**Appendix A11**  
**Marine Physical Processes  
Numerical Modelling**

## North Irish Sea Array (NISA) Offshore Wind Farm

## Marine Physical Processes Numerical Modelling

03 June 2026

Figure A4.5: Time-series comparison of modelled and measured depth-average current directions, Site A (replaces Figure 4.11 in Appendix 10.2 of the 2024 EIAR).

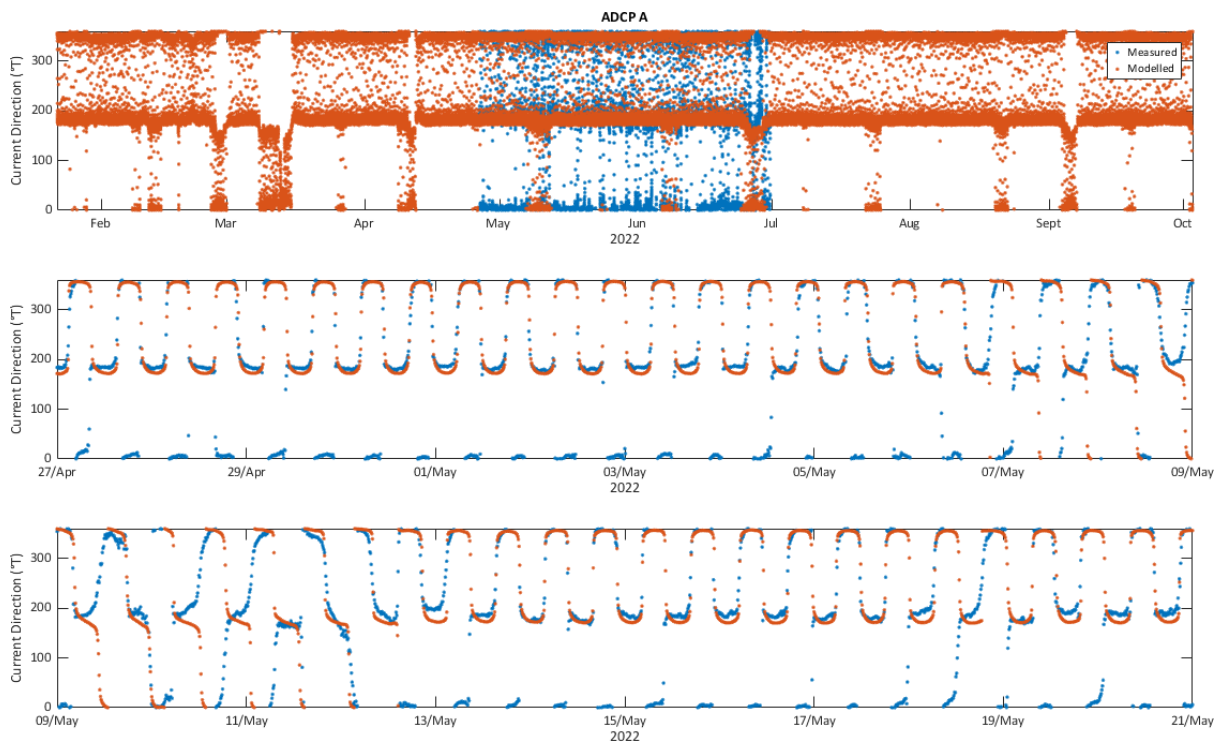
7 (b)	The labels on the directional plots on Figures 4.11 and 4.13 within Chapter 10 of the EIAR are incorrect. The applicant is requested to address this issue.	The labels on the directional plots on Figures A4.5 and A4.6 in A10.2 have been corrected as requested.
7 (c)	The applicant is requested to submit time series plots comparing simulated wave events relative to recorded wave buoy data including direction, period and wave height or water surface elevation (WSE).	Time series plots comparing simulated wave events have been provided in in Section 5.4 of Appendix A10.2.
7 (d)	The modelling undertaken in support of Chapter 10 of the EIAR does not demonstrate spatial variation of bed friction or bed shear stress values across the model domain. The	Confirmation of the modelling utilising a spatially-varying bed roughness across the model domain is provided in Section 4.3 of Appendix A10.2.

The changes in this section are additional figures provided in response to RFI Sections 7 (a) and 7 (b). Figures A4.1 to A4.4 illustrate the comparison of measured and modelled depth-average currents, for Sites A and B, during neap and spring tidal periods. Figure A4.5 and Figure A4.6 replace Figures 4.11 and 4.13 in Appendix 10.2 of the 2024 EIAR respectively with corrected labels.

Figure A6.1. Locations used in particle tracking modelling (replaces Figure 6.1 in Appendix 10.2 of the 2024 EIAR).

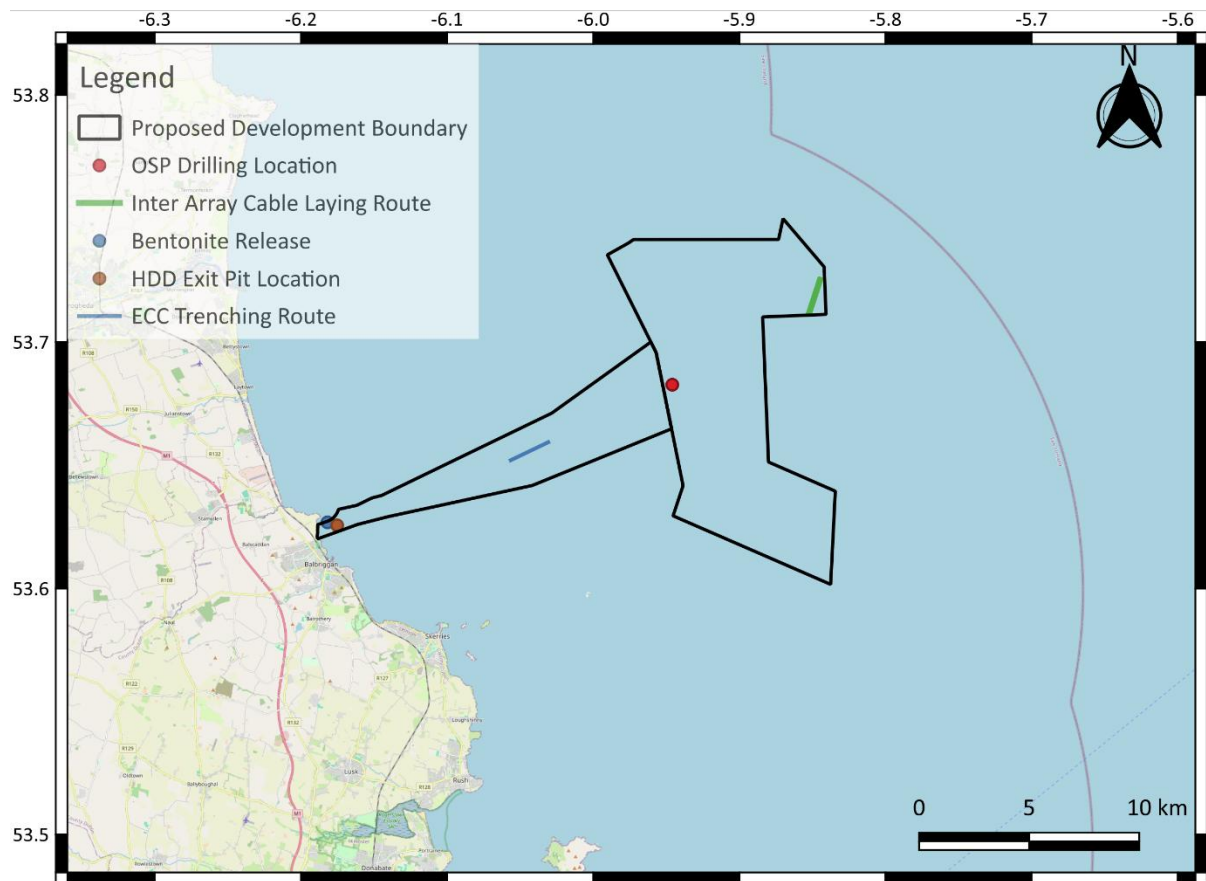
Figure 6.1 in Appendix 10.2 of the 2024 EIAR shall be deleted and replaced with Figure A6.1, illustrating updated particle tracking release locations.

The geographical positions of each of the sediment release locations described below are shown in Figure A6.1. In each case, these locations are associated with the highest concentration of fine sediments in the seabed which are expected to lead to the largest suspended sediment concentrations within the short-term duration of plume
